Title - Sujet Fire Suppression System&Fire Alarm Fire Suppression System and Fire Alarm Replacement	
Solicitation No. - N° de l'invitation EP076-201304/A	Amendment No. - N° modif. 009
Client Reference No. - N° de référence du client 20201304	Date 2021-03-31
GETS Reference No. - N° de référence de SEAG PW-\$\$\$FG-374-79676	
File No. - N° de dossier fg374.EP076-201304	CCC No./N° CCC - FMS No./N° VME
Solicitation Closes - L'invitation prend fin at - à 02:00 PM Eastern Daylight Saving Time EDT on - le 2021-04-13 Heure Avancée de l'Est HAE	
F.O.B. - F.A.B. Plant-Usine: <input type="checkbox"/> Destination: <input checked="" type="checkbox"/> Other-Autre: <input type="checkbox"/>	
Address Enquiries to: - Adresser toutes questions à: Vani-Machado, Alba	Buyer Id - Id de l'acheteur fg374
Telephone No. - N° de téléphone (873) 355-4048 ()	FAX No. - N° de FAX () -
Destination - of Goods, Services, and Construction: Destination - des biens, services et construction:

Addendum 4

T58 Building Fire Suppression System Questions
Solicitation – EP076-201304

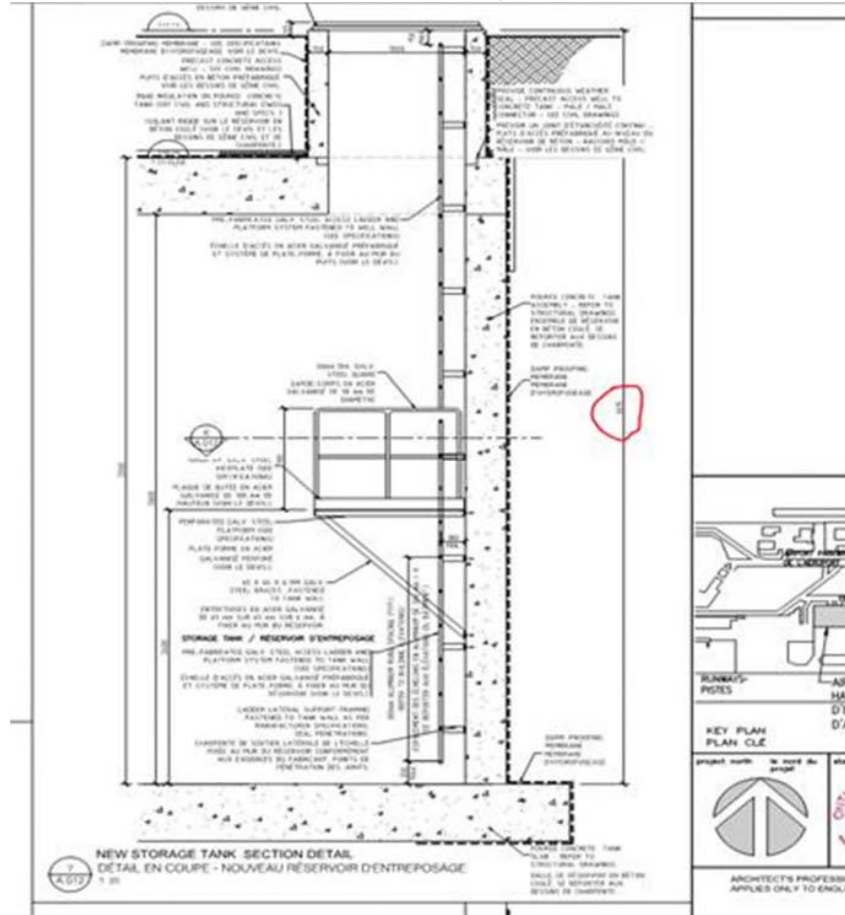
Q 23 - 1) Detail 7/A.012 shows a different height of the storage tank concrete wall than what's shown on structural drawings. Please clarify required wall height?

A 23 – Dimensions shown on 7/A.012 match the structural drawings. The dimensions with the red circle is at the access hatches only and this matches the civil drawings, detail D07. The elevation on detail 7/A.012 match the elevation on one of the hatches, the other varies slightly. The dimensions on the other side of detail 7/A.012 dimensions the main part of the storage tank and match the structural. No change to the documents required.

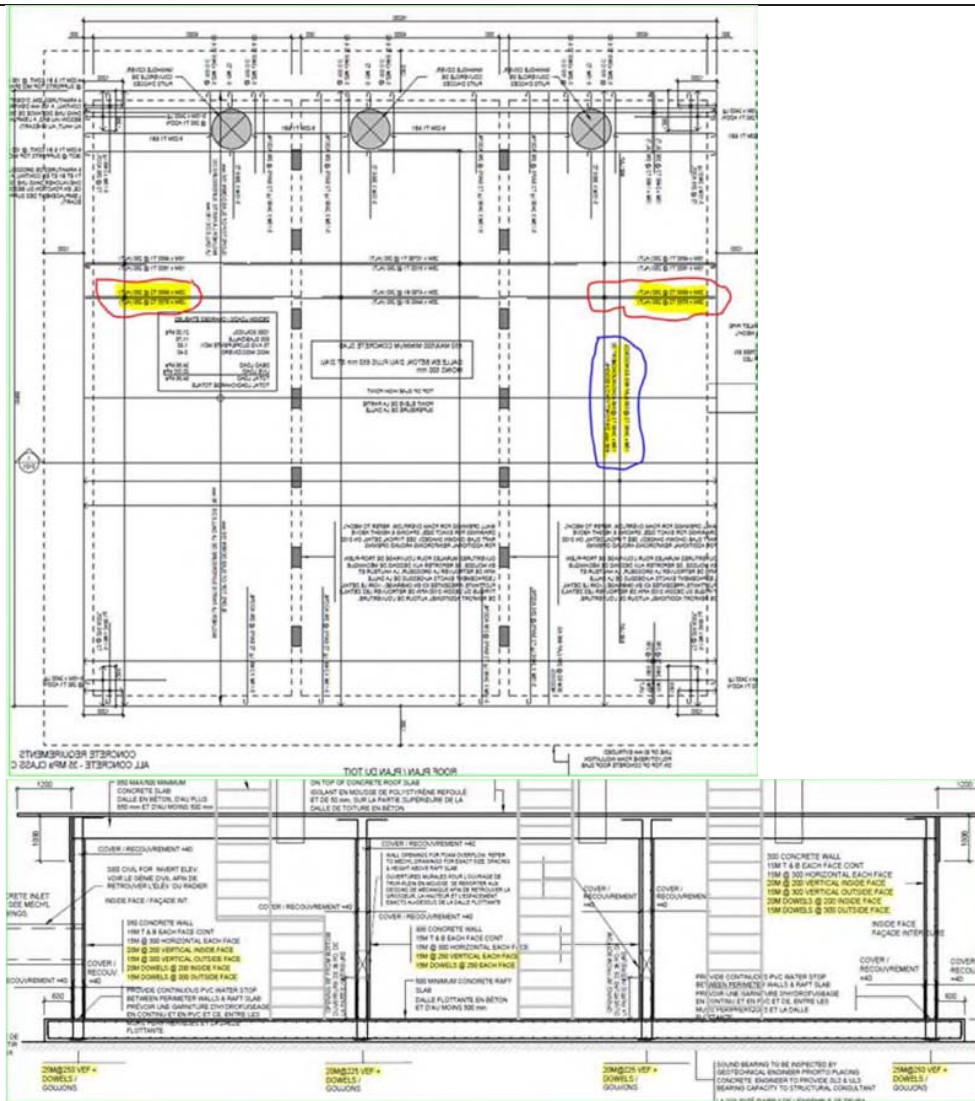
Q 30 - In drawing S102, section A-A/S101 – CROSS-SECTION, the wall reinforcement is shown on the side of each wall. Also bottom of each wall is shown vertical reinforcement which is different from the vertical reinforcement shown on the side of the walls. See section “A-A” below. Can you please clarify which vertical reinforcement should be used?	A 30 – We have revised our wall reinforcement in section A-A/S102, refer to clouded areas on S102 in addendum for further details.

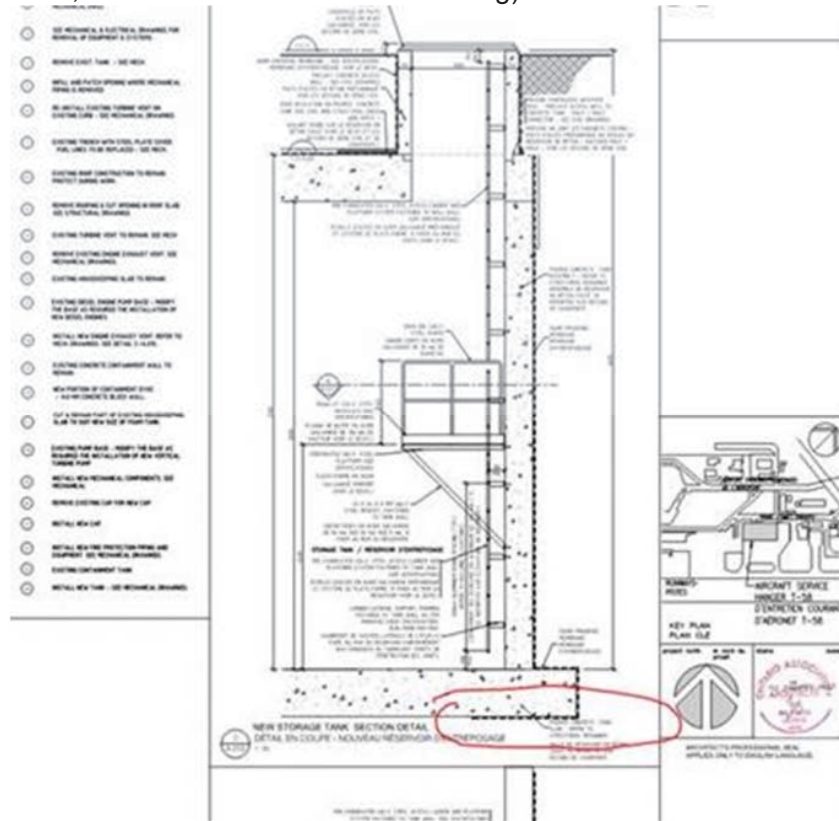
Q 32 - Detail 7/A.12 shows damp-proofing membrane extending under the tank footing. Please confirm if the damp-proofing membrane has to go around the whole tank (including walls, above slab and under tank footing)?

A 32 – Dampproof membrane to stop at bottom of footing. Part of dampproof membrane under footing will be deleted in Addendum.

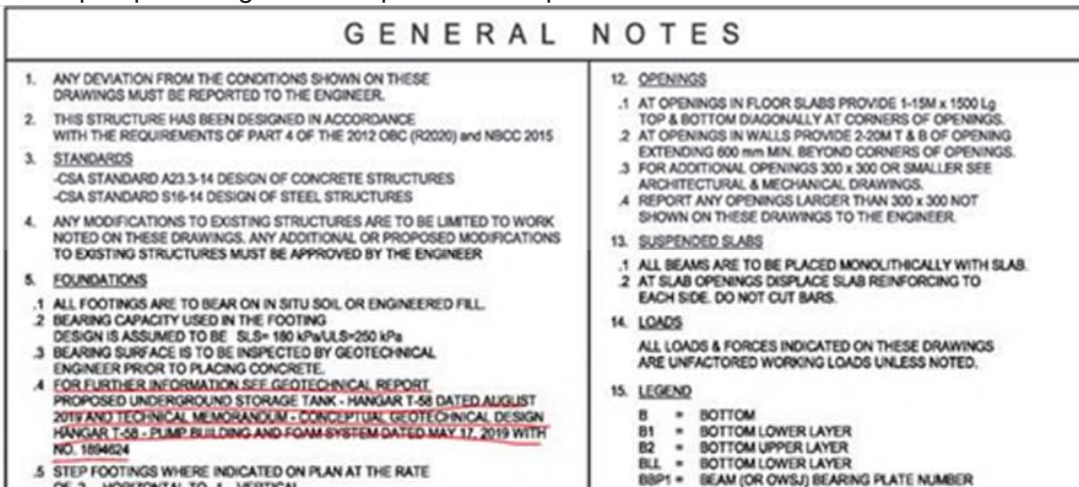
Q 34 - Considering that the construction of new valve room (phase 1A) and construction of new storage tank and exterior civil (phase 2) work will have some work overlap, can you please confirm if these phases (1A & 2) can be done at the same time?

A 34 – Phasing overlap is understood and acceptable. All construction activities and modifications to the phasing plan are subject to review and
